3365 Commercial Drive and 1695-1775 East 18th Avenue PROPOSED CONDITIONS OF APPROVAL

CONDITIONS OF APPROVAL OF THE FORM OF DEVELOPMENT

On behalf of the Director of Planning, your application has been approved to develop on this site a 6-storey Multiple Dwelling building on the east portion containing 111 secured market rental dwelling units and a 3-storey market Infill Two Family Dwelling at the northwest side, and restore, retain, designate as Heritage "C", and relocate the existing 3-storey house at 3365 Commercial Drive to the southwest side of the site to convert to a Multiple Conversion Dwelling containing 2 market dwelling units, all above one level of underground parking accessed from East 18th Avenue, thereby providing a total of 115 dwelling units on this site.

Geotechnical Section at Tree 1650

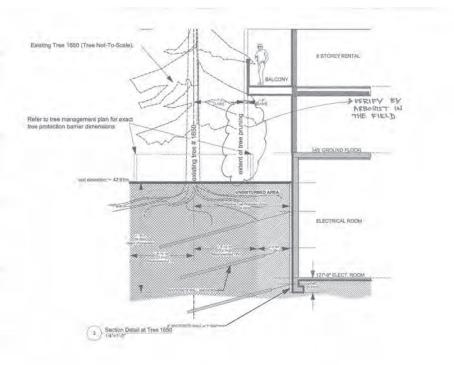
1.26 clarification on the architectural and landscape plans/ sections and the arborist report of efforts to minimize disturbance of the tree root protection zone and canopy clearance;

Note to Applicant: applicable to trees # 1646 -1650, 1677 and 1678. The tree protection plans and sections provided in the submission should be expanded. Employ vertical excavation and special concrete forming methods. The revised architectural and landscape plans/ sections should be highly detailed, with accurate dimensions through all tree protection zones, the excavation profile and the built structure. Key construction methods, tree protection barriers and any special arborist services drawn out of the arborist report should be noted. The methods of construction and tree protection strategy should be clear and 'stand alone' on the plans/ sections without having to defer to the arborist report. Further commentary may be necessary.

The sections provided in the submission have been expanded to clearly show tree protection dimensions, excavation profile, tree protection fencing and built structure. Notes have been pulled from the Tree Managament Plan and the Arborsit report such that the methods of construction and tree protection strategy are clear and 'stand alone' on the sections. (See A3.03 to A3.05)
